DATE: October 6, 2025
TO: Planning Commission Chair and Planning Commission Members
FROM: James A. Lower Village Manager
RE: Preliminary Plat Review- Allen Edwin Homes (Bedford Falls)

PRELIMINARY PLAT
BEDFORD FALLS SOUTH

Re: Bedford Falls South – Preliminary Plat Review
SDA Review No. SP25-001

P1

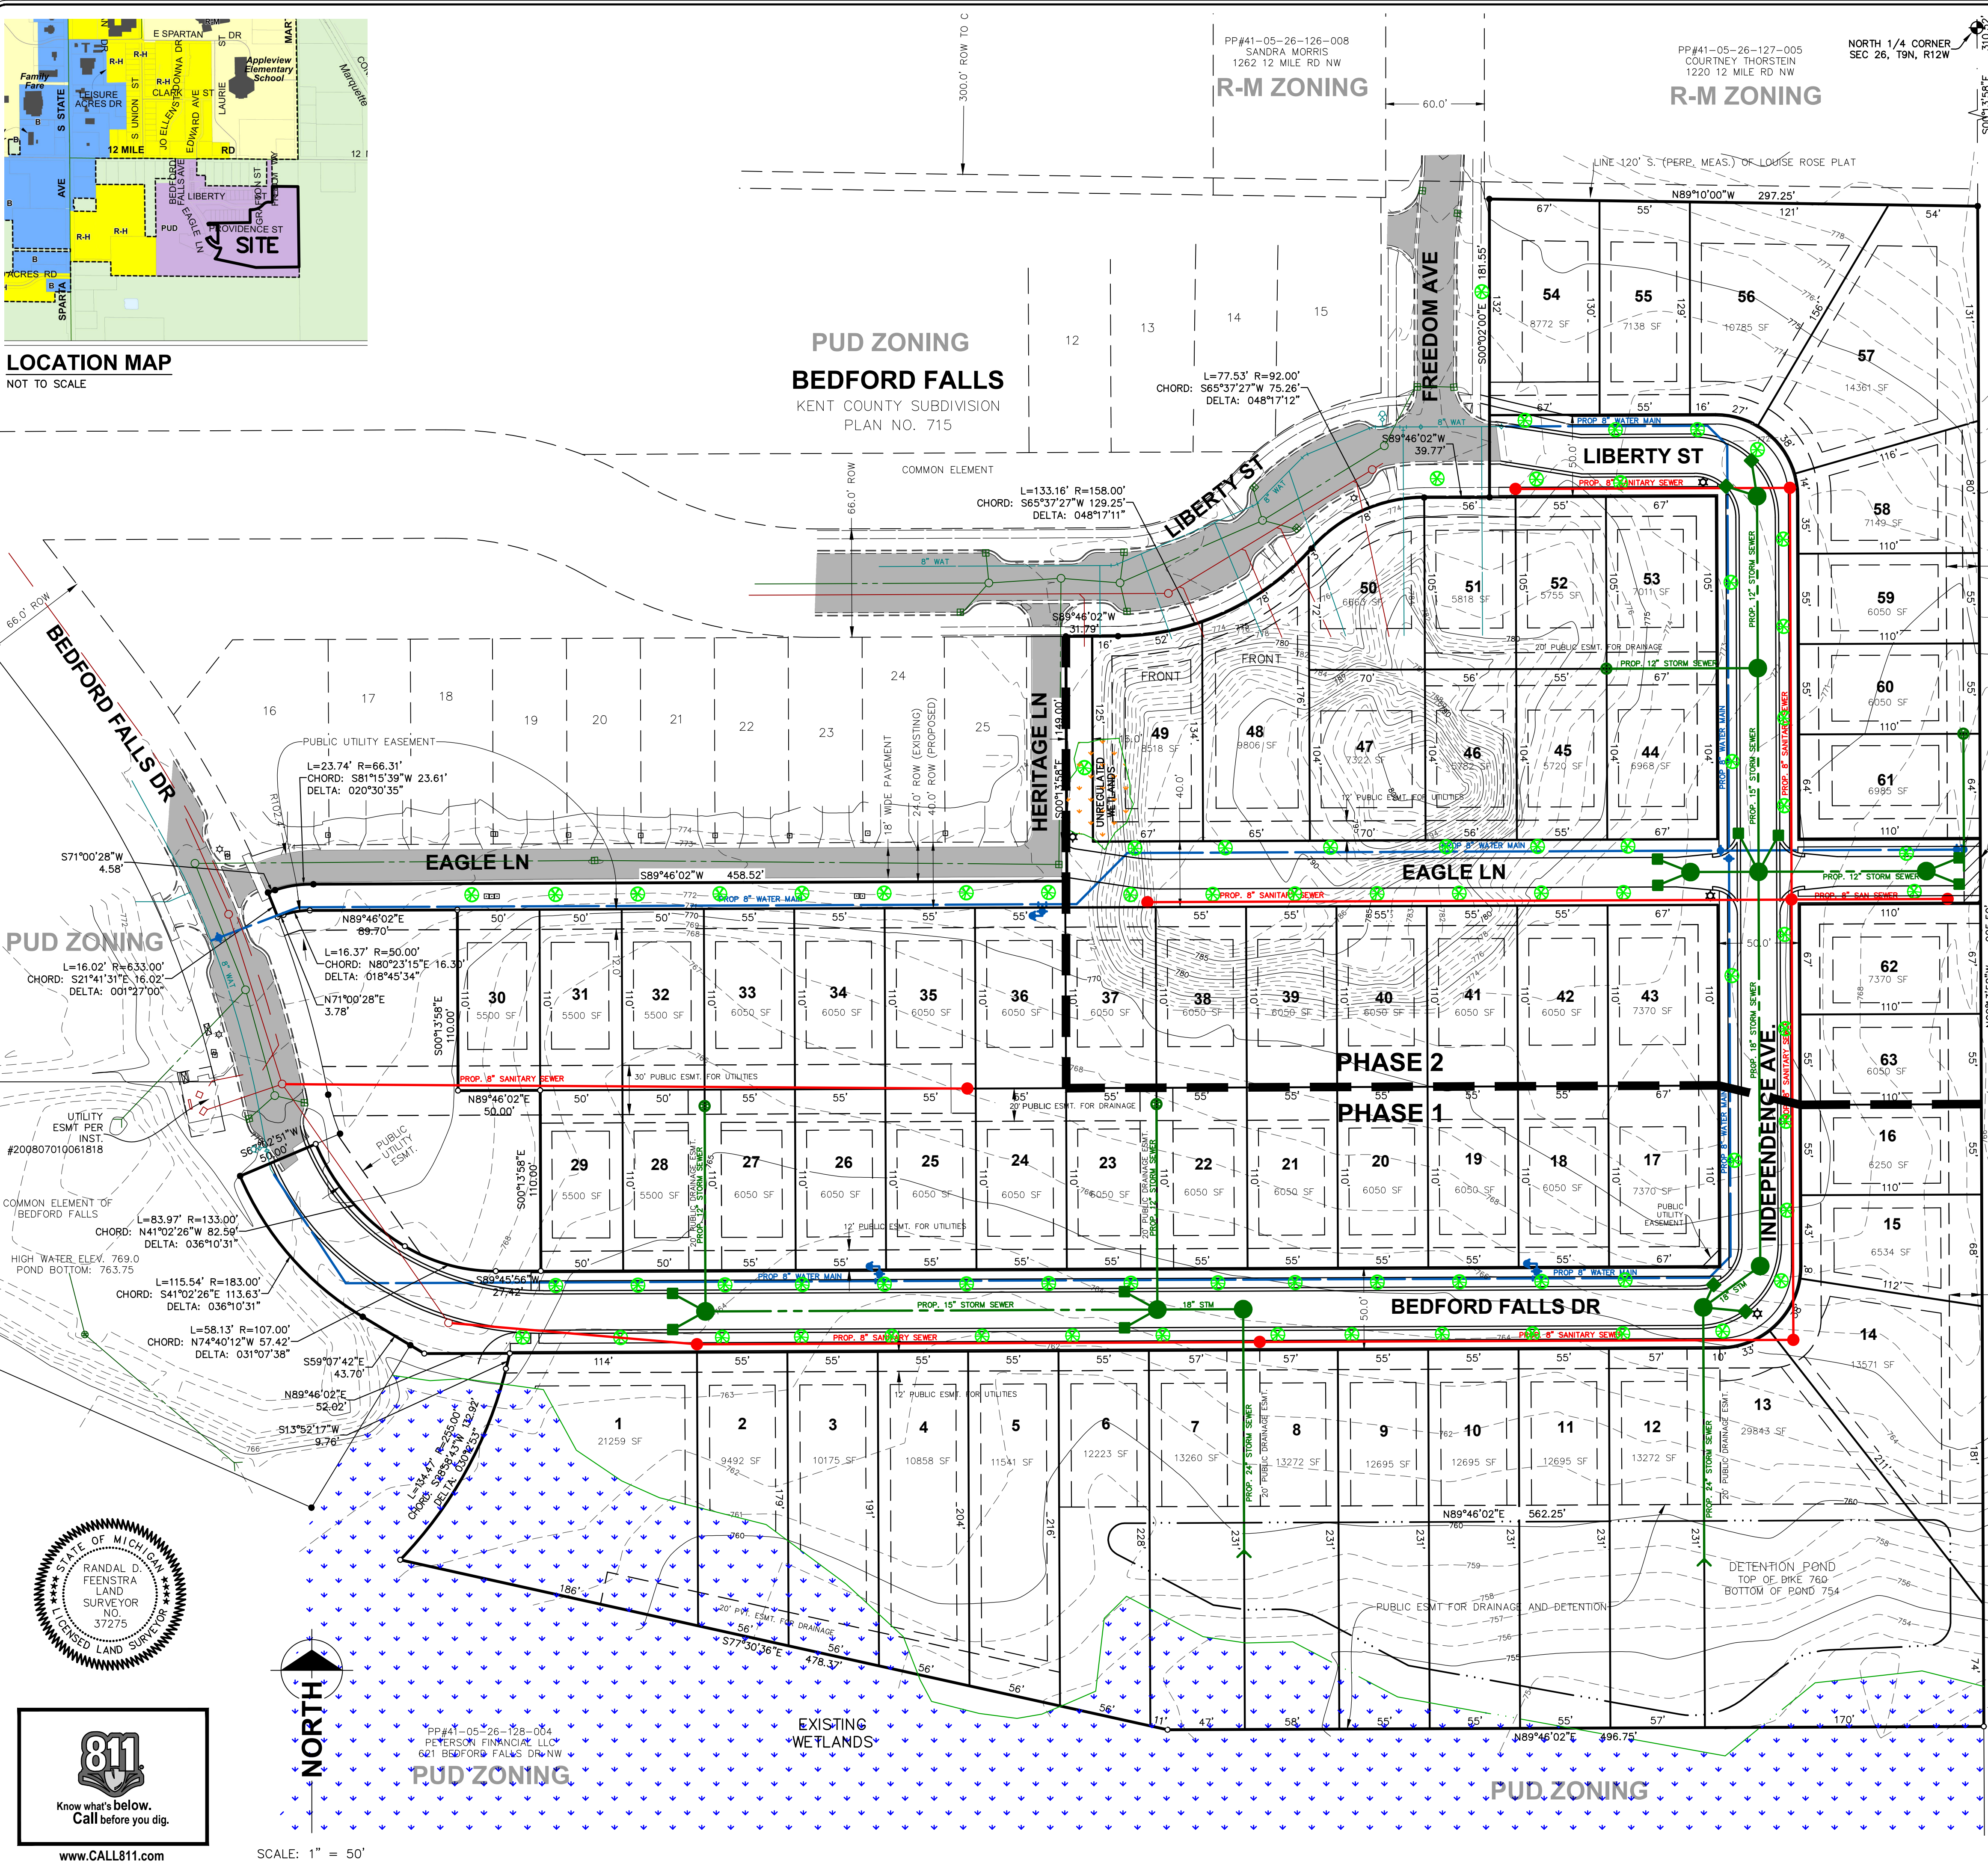
1. The Right-of-Way (ROW) being proposed differs from existing road ROW and Village standards
 - a. The existing Bedford Falls Drive and Liberty Street ROWs are both 66' wide and the proposed connection, which loops the two roadways, is 50' wide. While this varies from the 66' minimum required ROW as laid out in the Sparta Code of Ordinances, Section 62-126 (2), it is recommended that the Village consider accepting the revised ROW widths due to the constraints of the property along with additional public utility easements being provided on each side of the ROW allowing for sufficient room for all necessary utilities.

- b. On the existing portion of Eagle Lane, the ROW is 24' wide. The proposed plat includes a 16' wide addition to the ROW along the existing portion of Eagle Lane to expand that right-of-way space to 40'. The proposed connection would have a 40' ROW. While this varies from the 66' minimum required ROW as laid out in the Sparta Code of Ordinances, Section 62-126 (2), it is recommended that the Village consider accepting the revised ROW width, as it would maintain a consistent road width and layout as the existing Eagle Lane along with additional public utility easements being provided on each side of the ROW allowing for sufficient room for all necessary public utilities.

5. Lots 45-50, as shown have width to depth ratio that is not compliant with Sec. 82-114. Although these lots vary from the Sparta Code of Ordinances, it is recommended that the Village consider accepting the lot layout due to the necessity of the stormwater detention provided.

- a. Except for the width to depth ratio noted above, the lots appear to comply with the requirements of section 82-174.
6. Note 4 of the General Notes has a typo indicating 12" private easements for public utilities. The easement width should be 12' and all easements for public utilities should be public easements.

The plans show an existing 8" diameter water main located on the west side of Bedford Falls Drive and the north side of Liberty Street. The proposed 8" diameter water main would loop from the end of Bedford Falls Drive around to Liberty Street with another looped connection through Eagle back to Bedford Falls Drive. All proposed water main would remain within the proposed ROW.

The plans show an existing sanitary sewer located in Bedford Falls Drive and Liberty Street, but the plan does not list the size of the existing main. The proposed sanitary sewer main ranges between 8" and 12" with two separate connections to the existing main within Bedford Falls Drive. The proposed sanitary main would be primarily located within the proposed ROW, with one manhole located within the proposed public utility easement at the southeast corner of Bedford

1. There are several locations on the plat which call out private easements for drainage. All easements with public utilities should be designated as public easements.

2. While the 20' width of the easements varies from Sec. 62-153 of the Sparta Code of Ordinances which states a minimum 30' width for underground utilities, it is recommended that the Village consider accepting the reduced easement width as these are believed to be sufficient widths for the proposed drainage infrastructure.

3. There is a proposed catch basin shown in the center of Eagle Lane that was carried over from a previous submittal that included an inverted crown section for Eagle Lane. It is recommended that this be revised to reflect the current proposed cross-section.

ALLEY CROSS SECTION
NOT TO SCALE

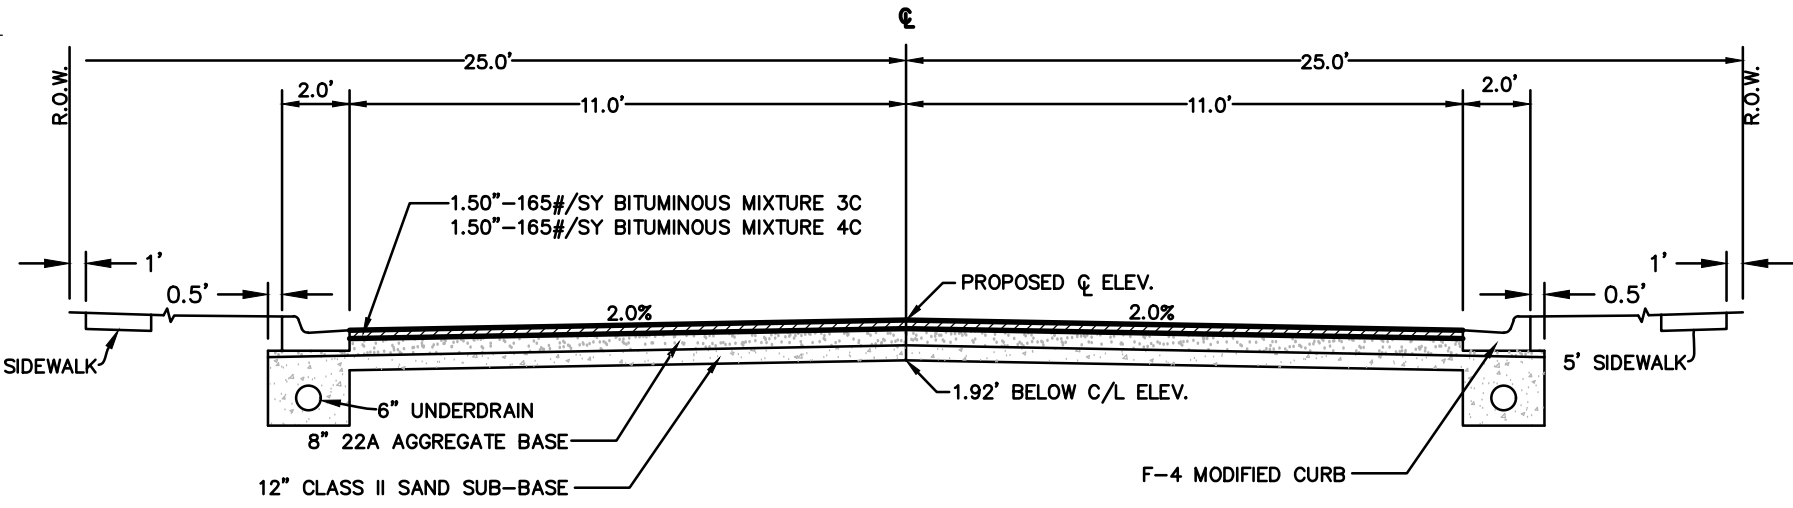
2. The road cross-section width displayed on the preliminary plat is 26' and does not meet the minimum 31' width as laid out in the Sparta Code of Ordinances, Section 62-15 (1). While this road width varies from the Ordinances, it is recommended that the Village consider accepting the reduced width due to the roads being purely residential and only being used

for circulation within the proposed subdivision. However, it is also recommended that future consideration be given to the restriction of on-street parking as this may interfere with two-way traffic flow.

3. The alley cross-section width displayed on the preliminary plat for Eagle Lane is 18' and does not meet the minimum 31' width as laid out in the Sparta Code of Ordinances, Section 62-15 (1). While this road width varies from the Sparta Code of Ordinances, it is recommended that the Village accept the reduced width due to the road width remaining consistent with the existing Eagle Lane along with the other roadways providing sufficient circulation within the subdivision. Additionally, while sidewalk is not present on Eagle Lane west of Independence Avenue, it is provided east of Independence Avenue which will maintain pedestrian access in the event of additional future development.

4. All roadways should be designed to drain away from the centerline of the road in accordance with a standard road cross-section as well as maintain a method of stormwater conveyance along the roadway. The alley cross-section provided shows a crowned roadway with no curb or ditching to carry the runoff to the storm sewer system. The alley cross-section is assumed to be applied to Eagle Lane which should be designated as an alley on the plan or cross section detail.
